AQUIND INTERCONNECTOR

Design and Access Statement - Tracked

Document Ref: 5.5

DATE: ~~23 DECEMBER 2020~~ 25 JANUARY 2021

Plate 4.1- Green panels and curved roofs

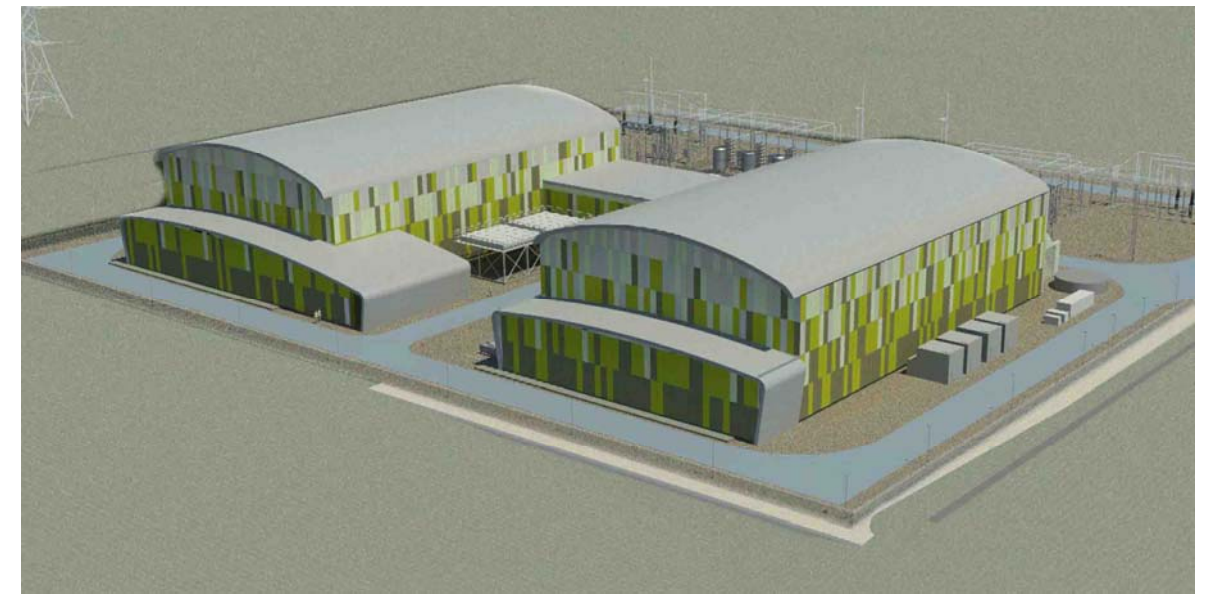
- **Comment:** Should the building be concealed or celebrated?
 - **Response:** This was a concept that was proposed by EHDC, but other attendees expressed a preference for concealment. The alternatives were debated and it was agreed that prominent curved roofs (Plate 4.1) would be discounted.

Plate 4.10 – Contextual colour studies

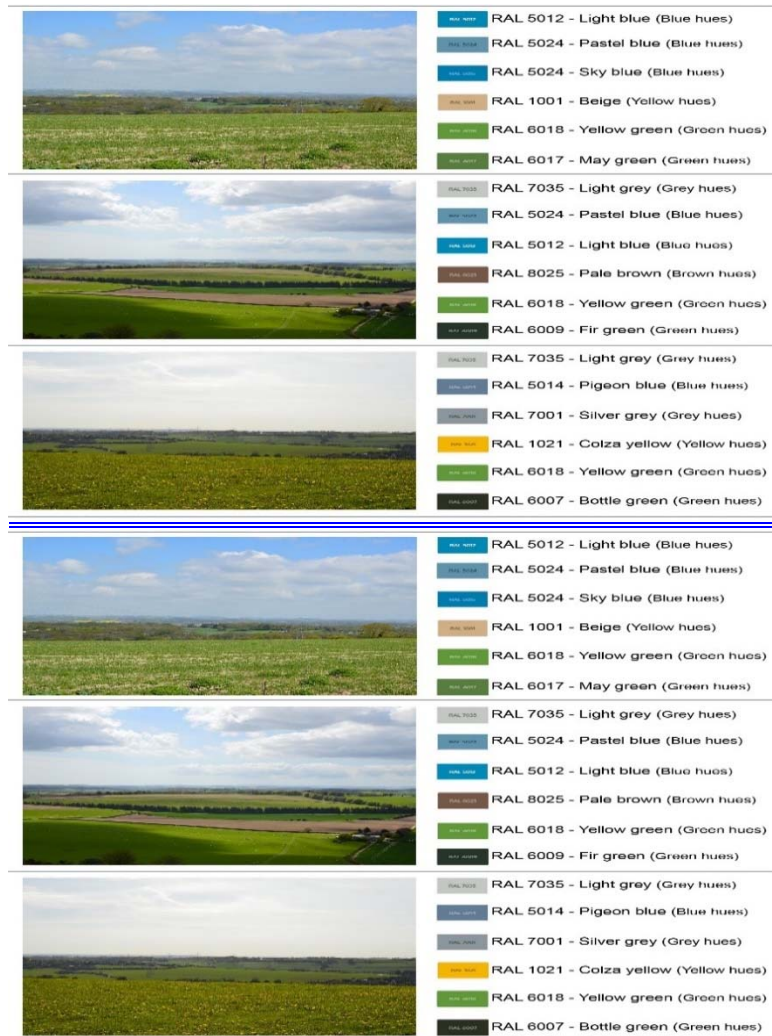
- **Comment:** (EHDC) Further development of contextual colour studies presented requested (refer to Plate 4.10 for studies presented). Variation and graduation of colours to different elevations considered.

- **Response:** Defined colour palettes will be developed from the contextual studies. Variation and graduation of colours to different elevations to be considered.

Plate 4.11– “Summer Greens” option.

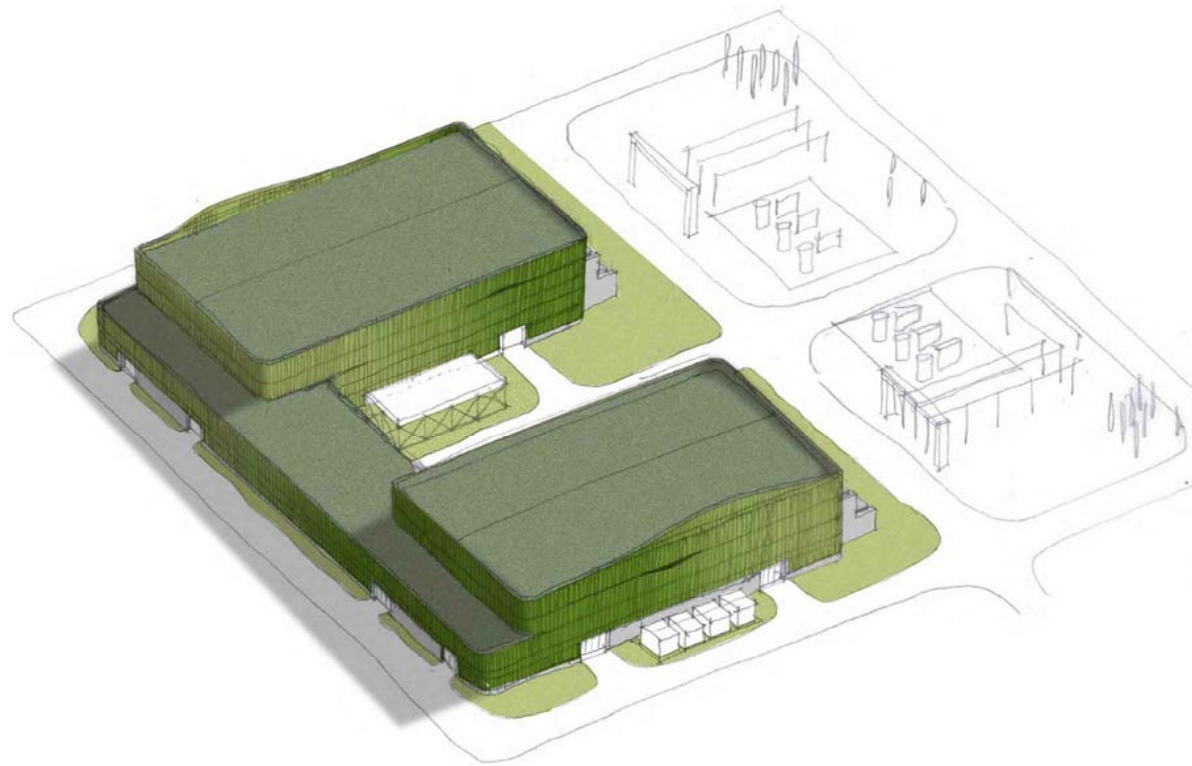
- **Response:** It was agreed to consider in further detailed design development
- **Comment:** (WCC and SDNPA) Agreement to discount the “summer greens” colour palette (refer to Plate 4.11).

- **Response:** Preference noted.
- **Comment:** (WCC) Request to ensure horizontal banding is included.
- **Response:** Agreed to retain and emphasise.
- **Comment:** (WCC and SDNPA) Concern expressed that “wave” forms to roof (refer to Plate 4.11) would have little impact when viewed from a distance.

- **Response:** Agreed to omit.
- **Comment:** (WCC) Request to consider blue/grey/brown colours.
- **Response:** Colour palettes to be investigated further for next meeting.
